## Product/Process Change Notice - PCN 14\_0069 Rev. -

**PCN Title:** Datasheet Change for ADSP-BF504, BF504F, BF506F Processors  
**Publication Date:** 19-May-2014  
**Effectivity Date:** 19-May-2014 *(the earliest date that a customer could expect to receive changed material)*

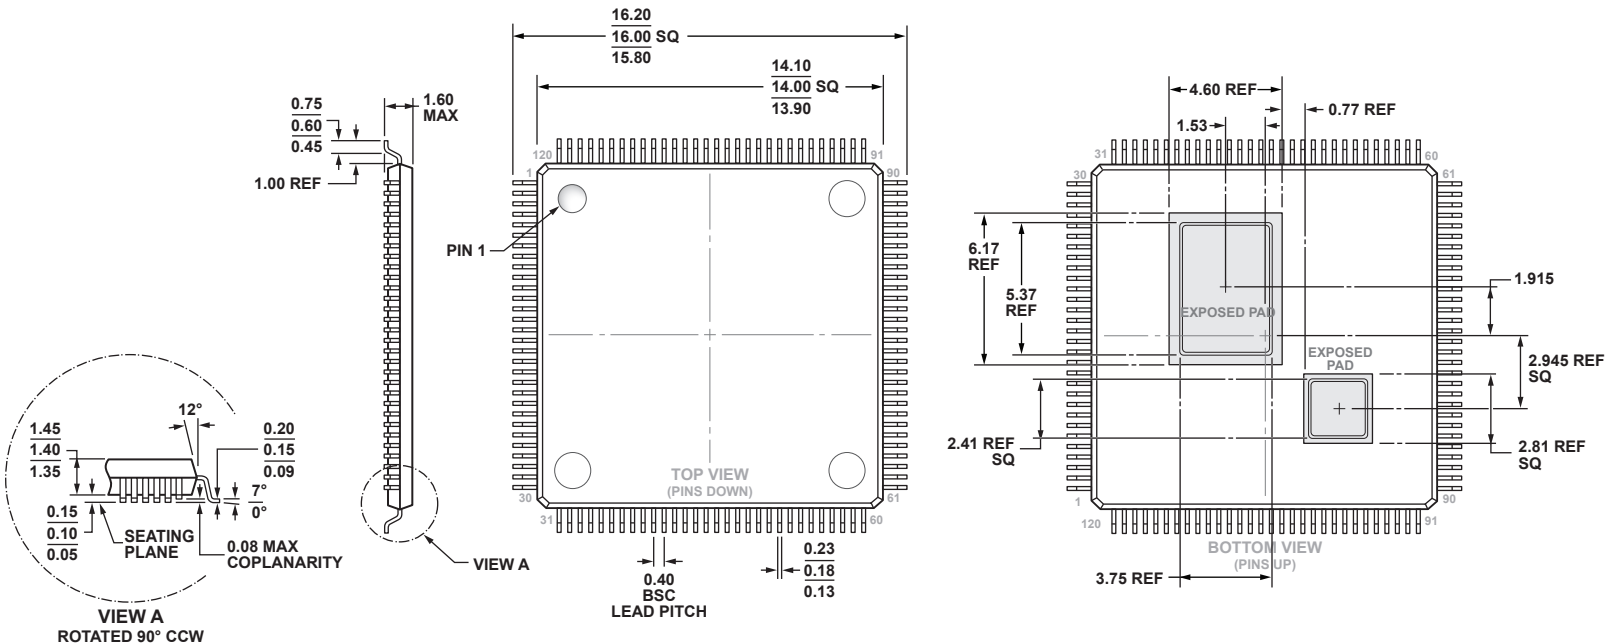
(2) Updated Package Outline Drawing to more accurately show the "U" shaped grooves around the exposed pads of the package. (See attached drawing)
